Technical Service Bulletin

94 Headlight cracked / water ingress into headlight lens

94 13 25 2034735/1 July 24, 2013.

Figure 4. Upper headlight housing cracking.

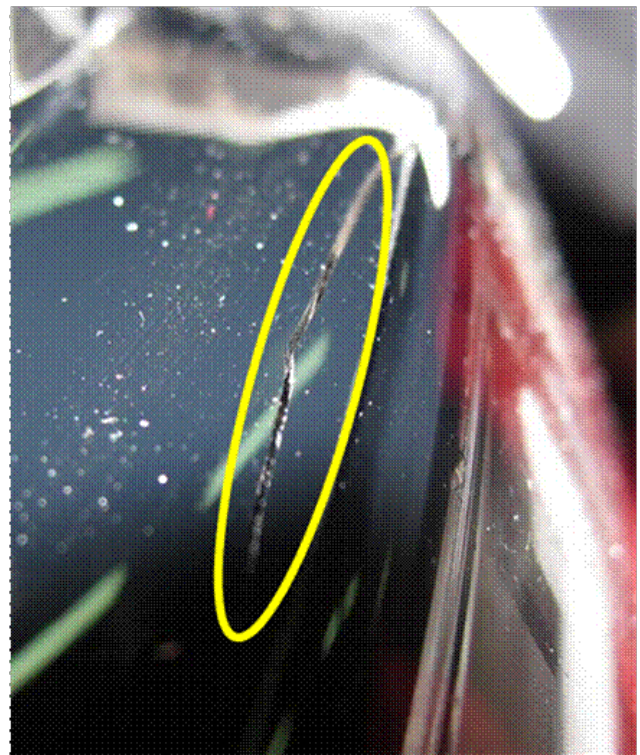
- Upper headlight housing cracking (at transition from lens to black surround) (Figure 4 and Figure 5).

The production process causes stress on the headlights from the bumper, as well as torsion force from installation.

Improved tempering of headlight glass.

Replace the affected headlight with the new part number:
